Agenda Item # 16

SUB-003750-2026

Cavallo Ridge Subdivision

- Subdivision approval to create 141 legal lots of record from four (4) metes-and-bounds parcels.

DETAIL SITE PLAN

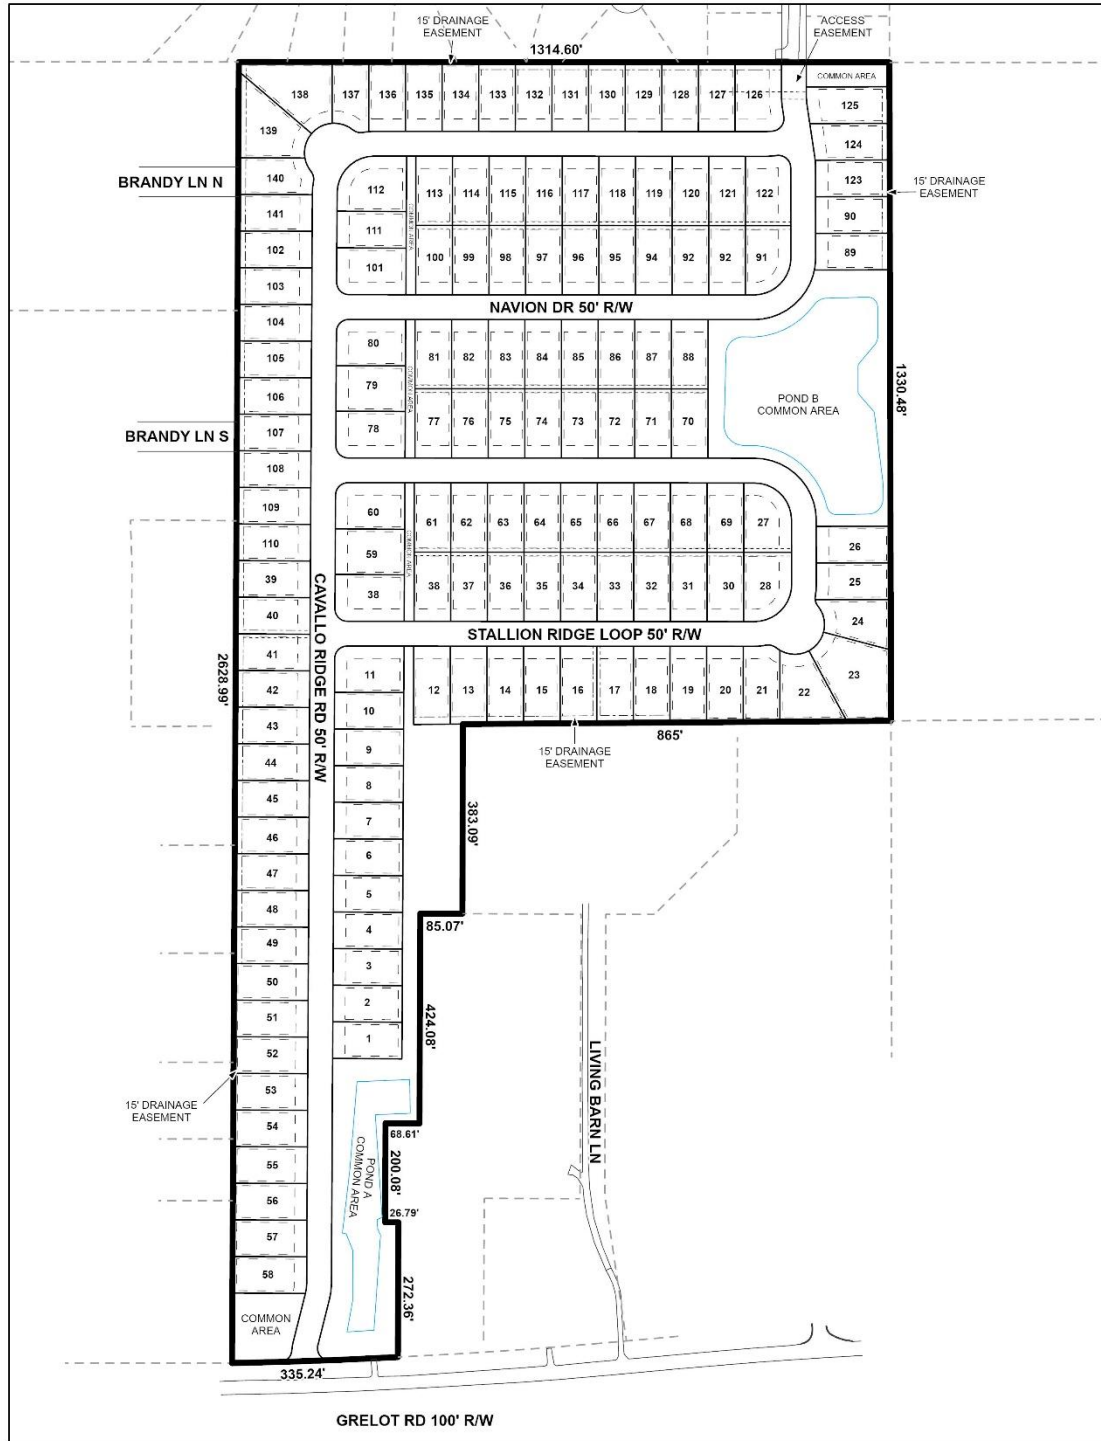
Access to the proposed subdivision is from Grelot Road, a Minor Arterial Street requiring a 100-foot-wide right-of-way at this location. A 100-foot-wide right-of-way is depicted on the preliminary plat, making additional dedication unnecessary.

Two (2) streets and an extension to Navion Drive are proposed for public dedication within the subdivision, labeled as *Cavallo Ridge Drive*, *Stallion Ridge Loop*, and *Navion Drive*. Each proposed street is depicted with a 50-foot-wide right-of-way, which is compatible with Section 6.B.9. of the Subdivision Regulations for streets equipped with curb and gutter.

Additional right-of-way is provided along portions of *Stallion Ridge Loop* and *Cavallo Ridge Drive* to accommodate partial turnarounds adjacent to proposed Lots 22, 23, and 24, and Lots 137, 138, 139, and 140. Although the dimensions of these rights-of-way are not labeled, they exceed the minimum 50-foot width required for streets with curb and gutter. If approved, the dimensions of these additional rights-of-way should be labeled on the Final Plat.

All proposed street names must be approved by the City Engineer to avoid duplication. Any revisions to the proposed street names, or the assignment of additional names to distinguish portions of a street, such as the northern segment of *Stallion Ridge Loop*, should be reflected on the Final Plat, if approved.

Proposed Lots 11, 27, 28, 38, 60, 78, 80, 91, 101, 112, 122, and 126 are corner lots subject to the 25-foot corner radius requirement of Section 6.C.6. of the Subdivision Regulations. A curve data table on the preliminary plat indicates that each corner lot provides a radius meeting or exceeding this requirement; therefore, no additional dedication is necessary. This table should be retained on the Final Plat, if approved.

Two (2) common areas are also located at the intersection of *Cavallo Ridge Drive* and Grelot Road. According to the curve data table, each provides a 25-foot corner radius, satisfying the requirements of Section 6.C.6. This information should also be retained on the Final Plat, if approved. As proposed, each of the lots will meet the minimum size requirement of Article 2, Section 64-2-5.E. of the Unified Development Code (UDC) for lots served by public water and sanitary sewer in the R-1 Suburban district. Lot sizes are labeled in both square feet and acres on the preliminary plat, as required by Section 5.A.2.(e)(4) of the Subdivision Regulations. If approved, this information should be retained on the Final Plat or provided in an accompanying table.

All but three (3) of the proposed lots meet the minimum 60-foot lot width requirement of Section 6.C.2(b)(2) of the Subdivision Regulations for residential lots within the Suburban sub-district. Proposed Lots 23, 138, and 139 have widths of approximately 49.13 feet, 47.87 feet, and 53.06 feet, respectively. Because these lots abut the proposed partial turnarounds, resulting in wedge-shaped configurations, but continue to satisfy the minimum lot area requirements of the UDC, a waiver of Section 6.C.2(b)(2) may be appropriate and will be required to accommodate the reduced lot widths, if approved.

Four (4) common areas are provided, each with their sizes labeled in square feet and acres on the preliminary plat in accordance with Section 5.A.2.(f) of the Subdivision Regulations. However, the common areas are not sequentially labeled, being identified as "Common Area 1," "Common Area 2," "Common Area 5," and "Common Area 7". If approved, these labels should be revised to provide a sequential numbering system or, alternatively, each area should simply be labeled "Common Area."

Front, side, and rear yard setbacks are depicted on each proposed lot. However, Section 6.C.8. of the Subdivision Regulations only requires the minimum front yard setback to be shown on a subdivision plat. Therefore, all side and rear yard setback lines should be removed from the Final Plat, if approved. In addition, the plat should be revised to depict a 25-foot front yard setback along each existing and proposed street where the adjacent

common area has a width of at least 60 feet, in compliance with Section 6.C.8. of the Subdivision Regulations and Article 2, Section 64-2-5.E. of the UDC. A 25-foot front yard setback should also be depicted along Navion Drive adjacent to the northernmost common area (currently labeled “Common Area 7”), despite that common area being less than 60 feet in width.

Multiple easements are depicted on the preliminary plat, including drainage and access easements. If approved, this information should be retained on the Final Plat along with the provision of a note stating that no structure shall be erected within any easement without the permission of the easement holder.

Finally, Section 7.C.4. of the Subdivision Regulations requires sidewalks to be constructed on both sides of all subdivision streets concurrently with development of each lot, as well as along common areas and other non-lotted areas. The preliminary plat includes a note reflecting this requirement, unless a sidewalk waiver is approved. This note should be retained on the Final Plat, if approved.

1. Retention of the 100-foot-wide right-of-way along Grelot Road, as depicted on the preliminary plat;
2. Retention of the 50-foot-wide rights-of-way along each proposed street, as depicted on the preliminary plat

3. Labeling of the dimensions of the additional right-of-way associated with the partial turnarounds adjacent to proposed Lots 22, 23, 24, 137, 138, 139, and 140, on the Final Plat;

4. Approval of all street names by the City Engineer prior to recording of the Final Plat, with any approved name changes reflected on the Final Plat;
5. Retention of the curve data table demonstrating compliance with the required 25-foot corner radii for all corner lots and common areas on the Final Plat;

6. Retention of lot area labels in both square feet and acres or in an accompanying table on the Final Plat;
7. Revision of the common area labels on the Final Plat to provide sequential numbering or, alternatively, labeling all such areas simply as “Common Area”;

8. Provision of a note on the Final Plat stating that the maintenance of all common areas shall be the responsibility of the property owner(s) and not the City of Mobile;

9. Removal of all side and rear yard setback lines from the Final Plat;
10. Depiction of a 25-foot front yard setback adjacent to all common areas where they are at least 60 feet in width, including the northernmost common area along Navion Drive, despite it being less than 60 feet wide;

11. Retention of all easements on the Final Plat, as depicted on the preliminary plat;
12. Provision of a note on the Final Plat stating that no structure shall be placed within any easement without the permission of the easement holder;

13. Retention of the sidewalk note on the Final Plat stating that sidewalks shall be constructed on both sides of the subdivision's streets and along common areas and other non-lotted areas in accordance with Section 7.C.4. of the Subdivision Regulations, unless a Sidewalk Waiver is approved;
14. Compliance with all Engineering comments noted in this staff report;
15. Placement of a note on the Final Plat stating all Traffic Engineering comments noted in this staff report;
16. Compliance with all Urban Forestry comments noted in this staff report; and,
17. Compliance with all Fire Department comments noted in this staff report.
